PREVOST

WARRANTY BULLETIN

WB15-25

DATE :	MAY 2015	SECTION :	12 - Brakes
EXPIRATION:	MAY 2017		
SUBJECT :	POSSIBLE INTERFERENCE BETWEEN CLAMP AND SHOCK ABSORBER

Figure 1

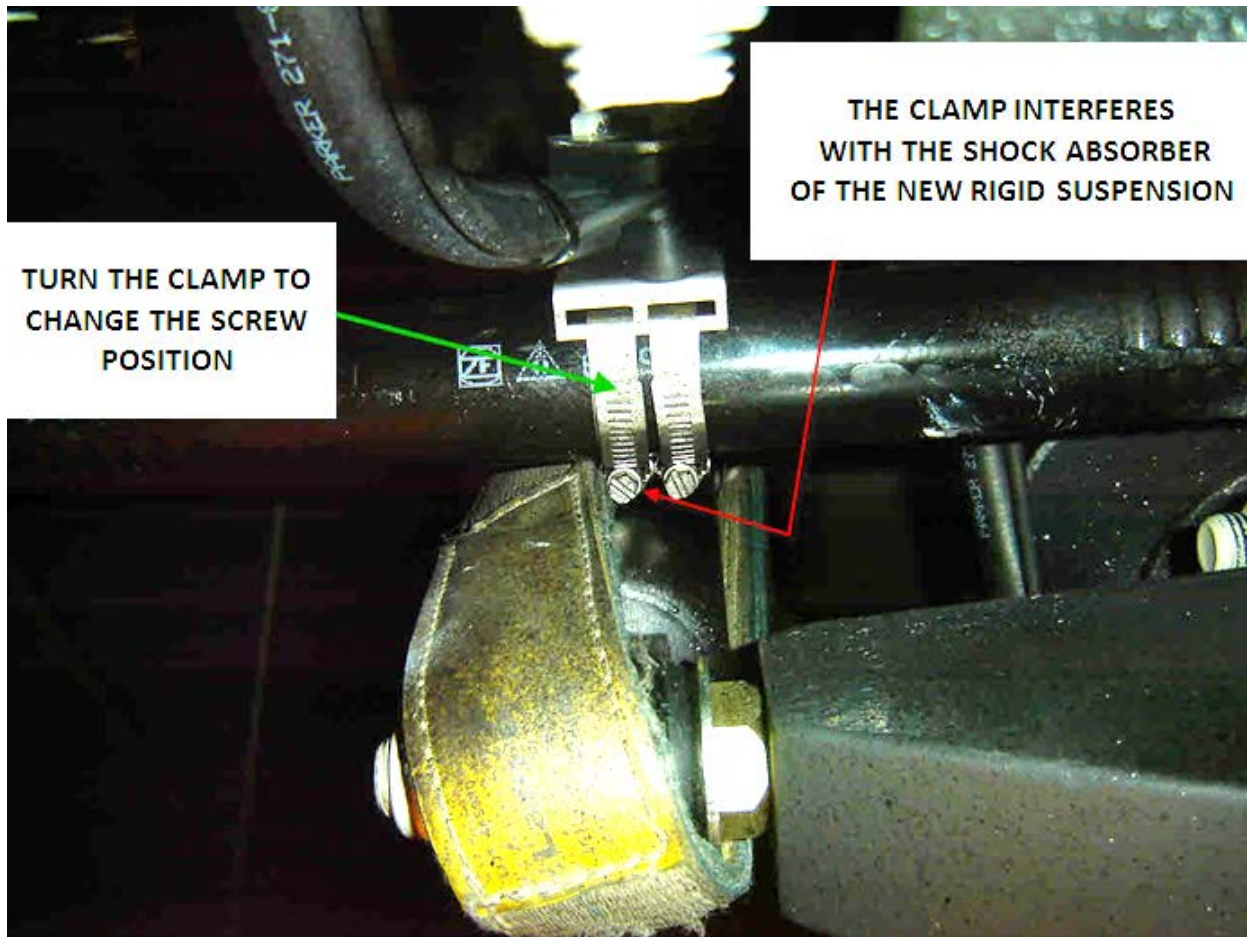
On the vehicles affected by this bulletin inspect the clamp retaining the brake hose supports to make sure it does not contact with the shock absorber.

1. On each side of the vehicle, make sure that the screw housing on the clamps is not close to the shock absorber. If it is, slack and turn the clamps one at a time, away from the interfering region, to have the housing about horizontal.
